UNITED STATES
DEPARTMENT OF THE INTERIOR
BUREAU OF LAND MANAGEMENTFORM APPROVED
OMB NO. 1004-0135
Expires: July 31, 2010**SUNDRY NOTICES AND REPORTS ON WELLS**
*Do not use this form for proposals to drill or to re-enter an abandoned well. Use form 3160-3 (APD) for such proposals.***SUBMIT IN TRIPLICATE - Other instructions on reverse side.**

** BLM REVISED ** BLM REVISED ** BLM REVISED ** BLM REVISED ** BLM REVISED **

Anemone ANE Federal #7
Sec 9-T22S-R24E
Eddy County, New Mexico
Page 2

WELL NAME: Anemone ANE Federal No. 7

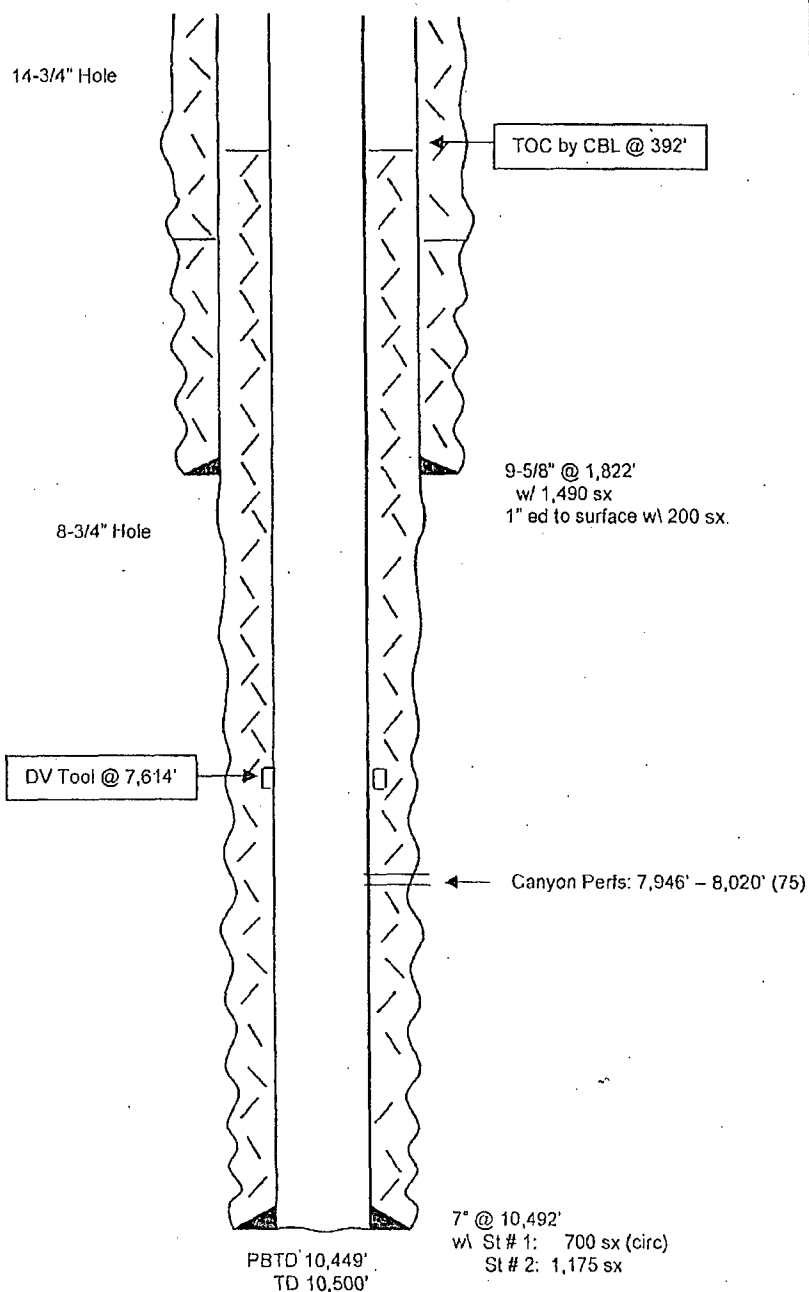
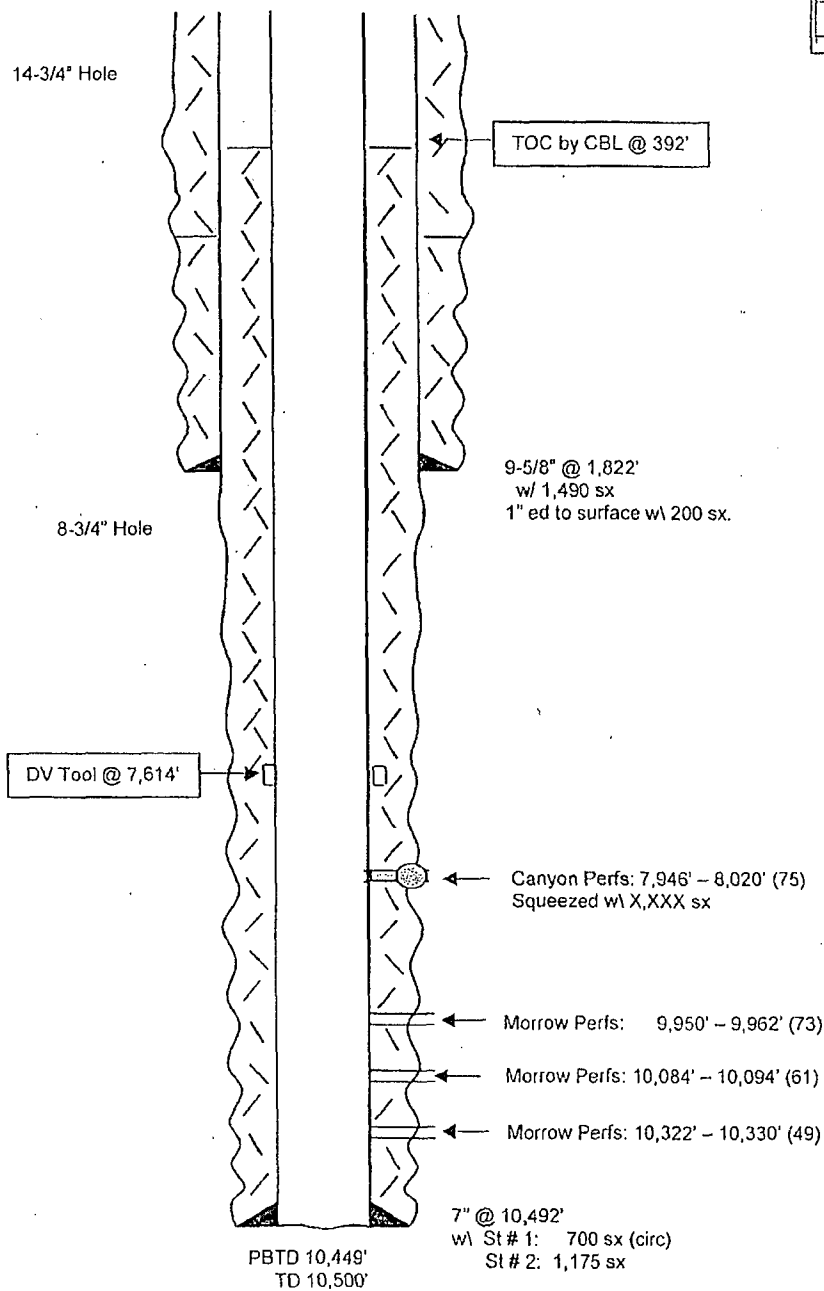
As per our telephone conversations I would like to test the Morrow sands below instead of the Straw/Atoka sand that we currently have approval to test.

We plan on perforating, acidizing and testing each zone if the testing warrant a CO@ foam frac would then be performed. I will send updated information to you

Mike the BLM concurs and approves the above plan of action.

Consider this the approval to revise the current sundry.
